Product Change Notification / NTDO-14MNBI131

CCB 5025 Final Notice: Qualification of G700 as a new mold compound material for selected Micrel MIC3490, MIC52xx, MIC62xxxM5, SPN020xxxx device families available in 5L SOT-23 package assembled at STAR assembly site.

Pre and Post Change Summary

QUALIFICATION REPORT SUMMARY
RELIABILITY LABORATORY

Pre Change

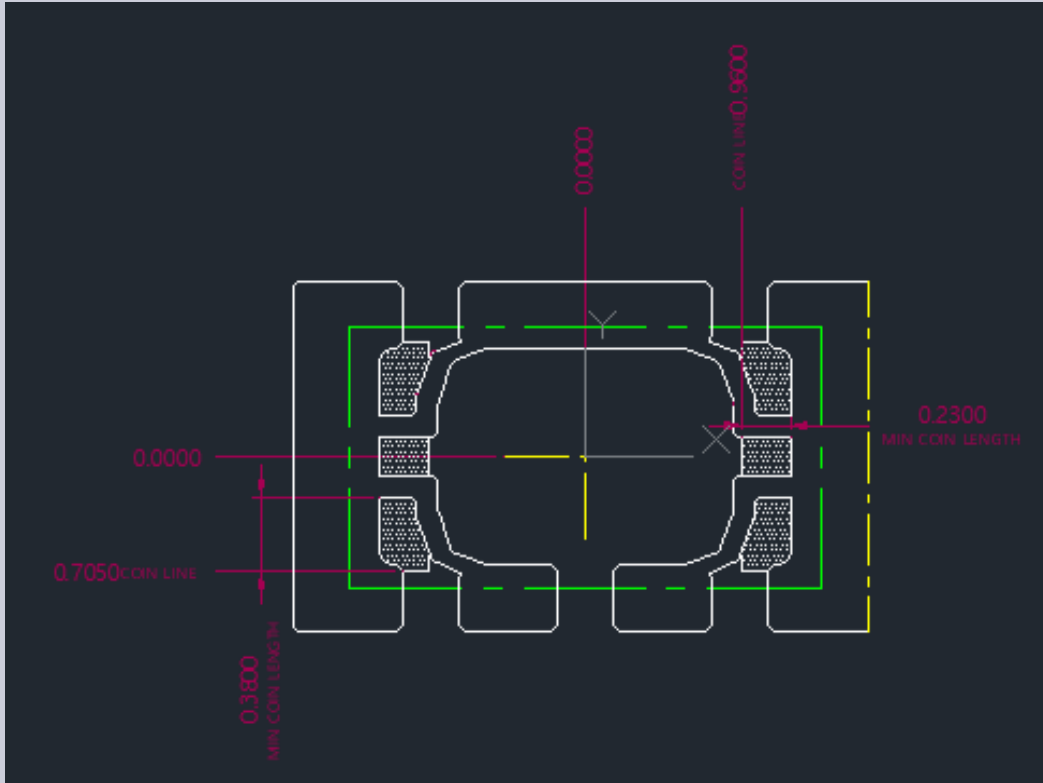
DAP Surface Prep
Lead-frame Material

NiPdAu with Roughened
C194

Post Change

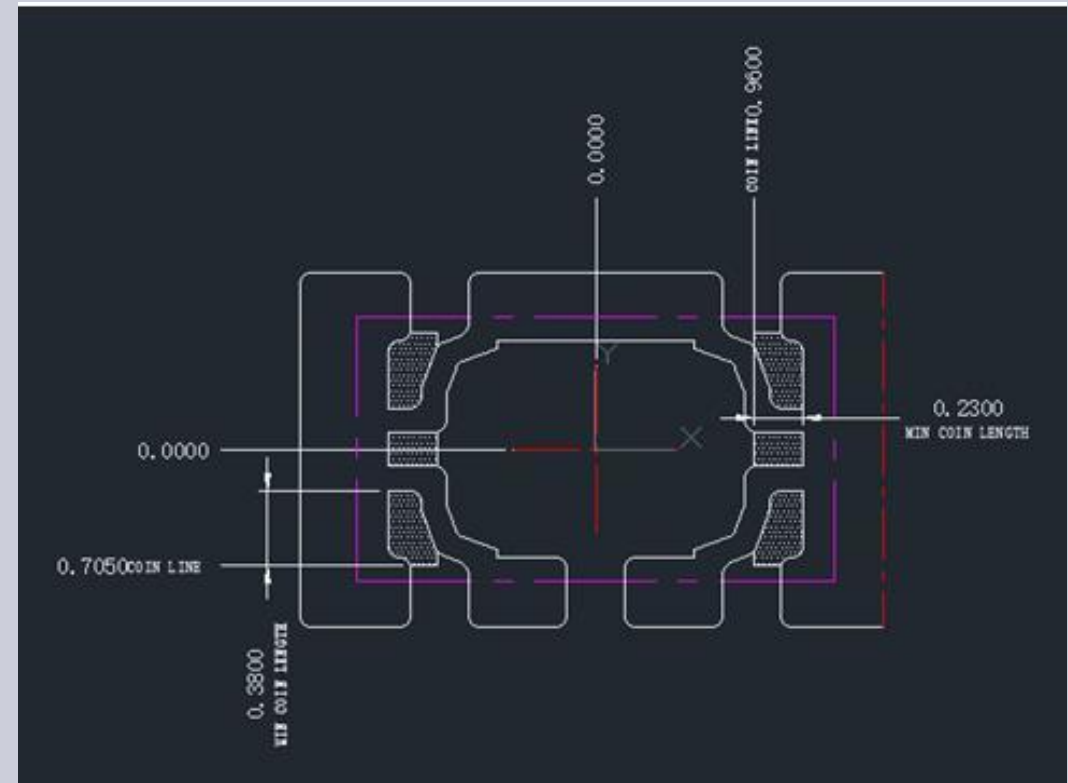
DAP Surface Prep
Lead-frame Material

NiPdAuAg with Roughened
C194
